# 1955 Corvette: Service Bulletin: Hard Shifting

<b>CHEVROLET—CENTRAL OFFICE</b> DIVISION OF GENERAL MOTORS CORPORATION DETROIT 2, MICHIGAN	
 <b>TECHNICAL SERVICE BULLETIN</b>  Service and Mechanical Department	
<b>SUBJECT:</b> HARD SHIFTING - 1955 MODEL PASSENGER CAR 3-SPEED TRANSMISSION	<b>BULLETIN No.</b> DR #236  <b>SECTION</b> VII
<b>TO:</b> ALL CHEVROLET DEALERS	January 9, 1956
<p>In cases where hard shifting on 1955 Passenger Models with 3-Speed Transmission is experienced in high frequency shifting operations due to malfunction and/or wear of gearshift controls and butting of transmission gears, the condition may be reduced by installation of a Transmission Control Conversion Kit and three new type transmission gears.</p> <p>The new transmission gears which have more tooth chamfer entered production about July 5, 1955.</p> <p>The revised transmission controls entered production beginning with 1956 Model and the Control Conversion Kit has modified parts for use on 1955 Models.</p>

FIGURE I

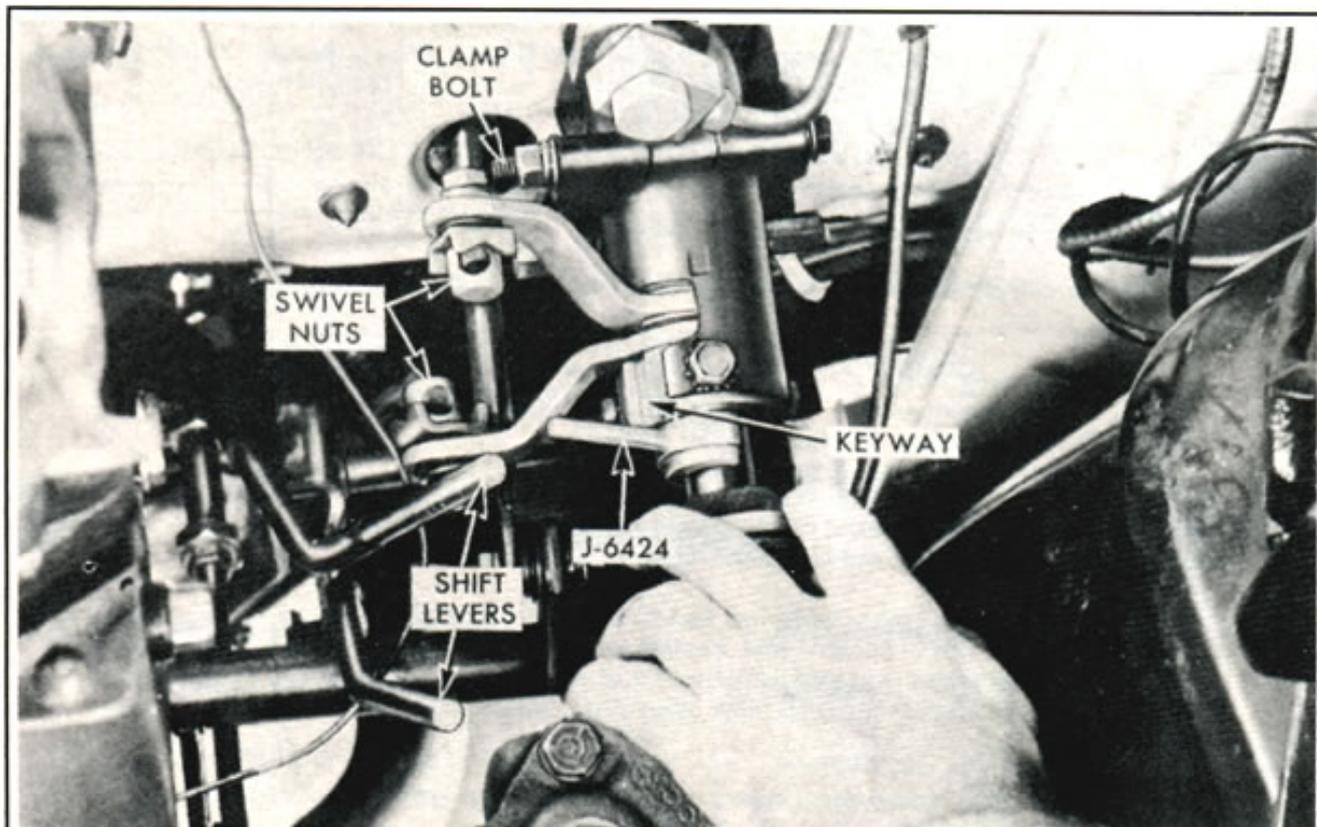
13. Insert gearshift rod ends in swivels - transmission must be in neutral detent in both ranges. Do not tighten.
14. Install alignment gauge J-6424 inserting side stamped "STD" between steering mainshaft and shifter tube in key area. This sets the required 1/16 eccentricity in proper relation to the key on shifter tube. See figure 1.

FIGURE 2

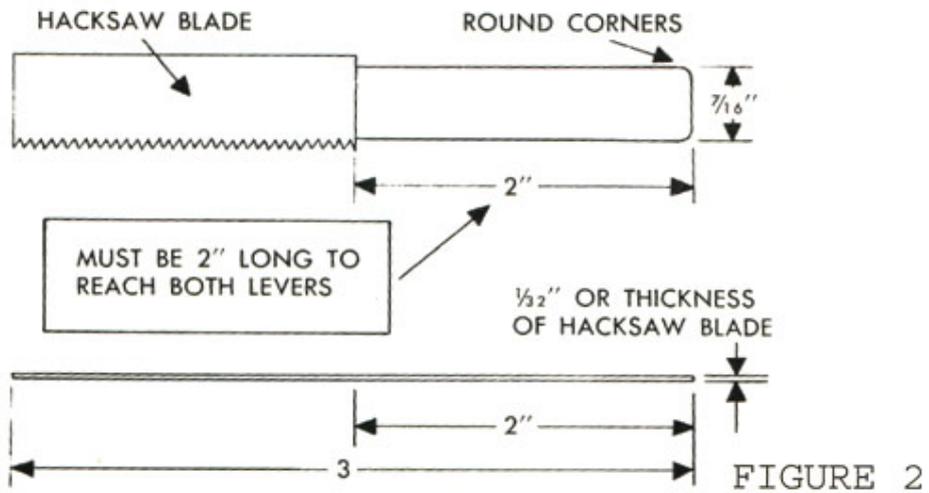
- c. Remove alignment gauge.
16. Make and insert special blade gauge, see figure 2, thru adjusting ring slot, lower levers and gate washer. Tighten swivels on gearshift rods while holding downward lightly on lower levers. Transmission must be in neutral detent at this time.

FIGURE 3

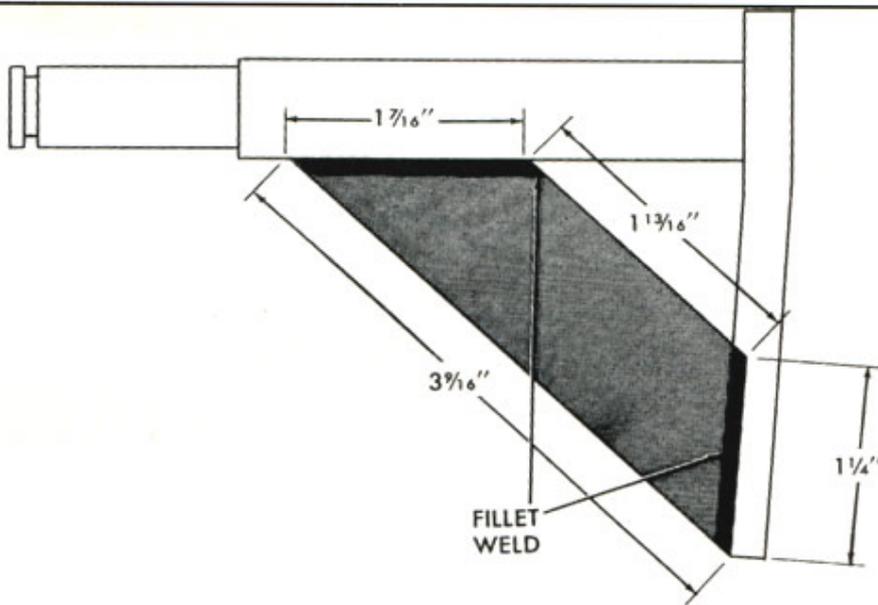
Further improvement of shifting can be made by reinforcement of transmission control rod idler lever support located on left frame rail under toe pan to reduce its deflection. See figure 3.
